RE: Comments for the Record
Cayuga Operating Company, LLC
SPDES Permit NY0001333
DEC No. 7-5032-00019-00004
228 Cayuga Drive, Lansing, New York

Technical Findings

Figure 1
Potentiometric Surface Diagram (Modified)
August 2006

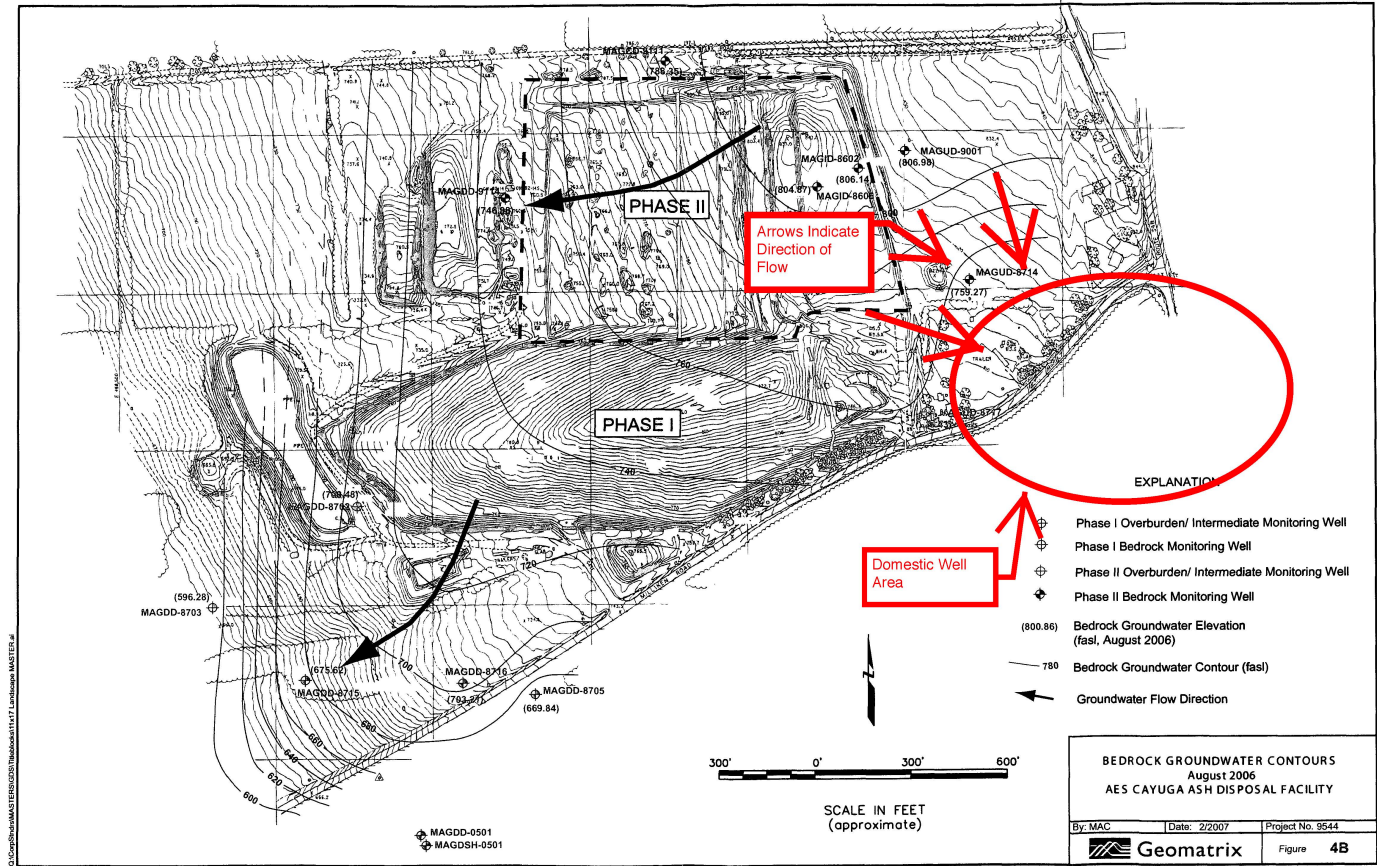
22. Although groundwater flow diagrams produced by Cayuga have illustrated a south-southeast bedrock groundwater flow direction⁵ *towards residential properties with domestic water supply wells*, there is no indication that Cayuga has ever sampled those wells. See attached **Figure 1**.

60. Cayuga’s conclusion in 2010 that MAGUXX-8303 and MAGUXX-7712 are “upgradient” and therefore do not represent groundwater flowing from beneath the landfill is not based upon fact or their own data. When the monitoring program at the landfill included more wells in that area (e.g. 2006, before wells were destroyed to construct a portion of the Phase 2 landfill), those bedrock wells are clearly hydraulically *downgradient* of both Phase 1 and Phase 2¹⁶. See attached **Figure 1**.

68. An independent search in January 2015 for water well users completed by Dr. John Dennis – Environmental Planner and Member of the Tompkins County Environmental Review Committee – identified at least 25 water wells within an approximate 1-mile radius of the landfill.
69. That search identified three water wells within approximately 1,000 feet of the southeastern corner of the landfill. See **Figure 1**.

Figure 2
Potentiometric Surface Diagram
June 2012 Bedrock Aquifer

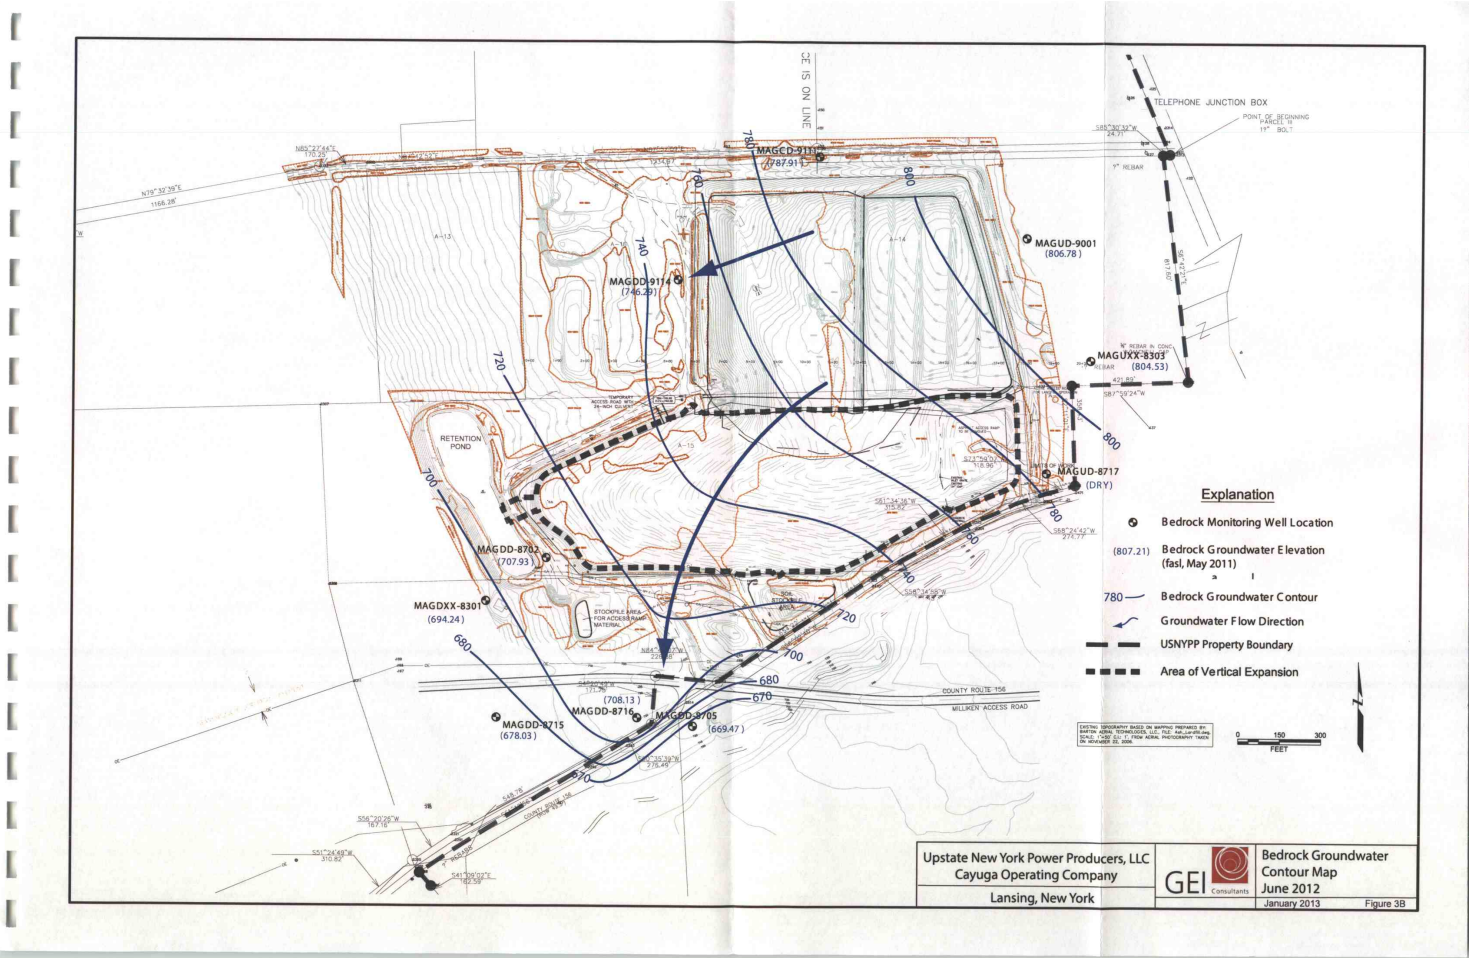
23. Cayuga’s most recent Environmental Monitoring Plan (2014) illustrates a dominant direction of flow instead towards the west-southwest. See attached **Figure 2**.
